Accumulator Shift Valve

63940-03K

Sonnax Part Summary

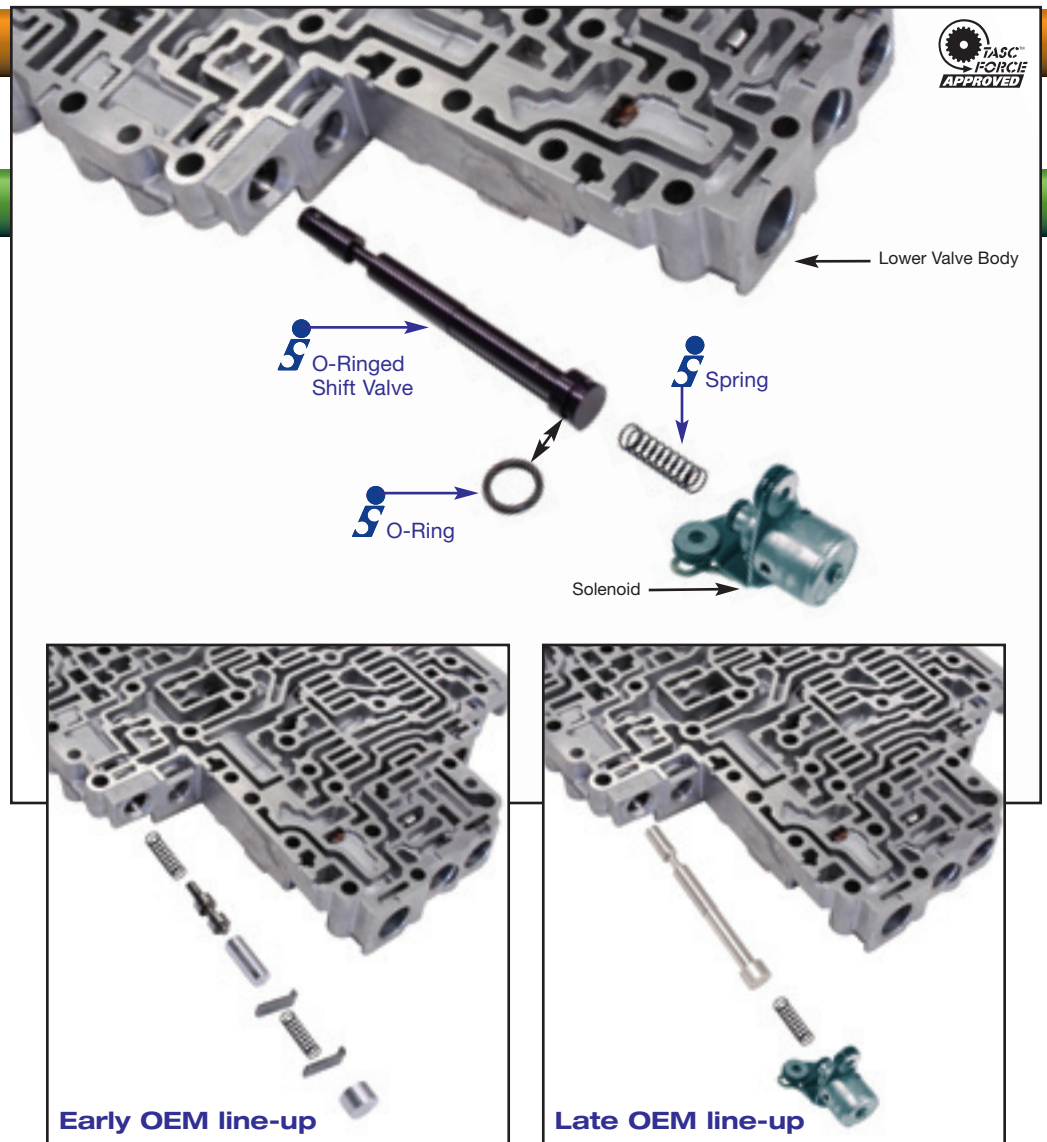
An out-of-position accumulator shift valve creates soft or flared upshifts.

The accumulator shift valve line-up has been changed numerous times by OEM, and incorrect reassembly can result in soft or flared upshifts. This kit includes an accumulator shift valve that will be correctly positioned to prevent soft or flared upshifts.

This updated design eliminates the OEM split valves and seals all circuits.

- Shift valve provides proper circuit flow to prevent soft or flared upshifts.
- Sonnax design replaces all OEM line-ups that use an accumulator shift valve.
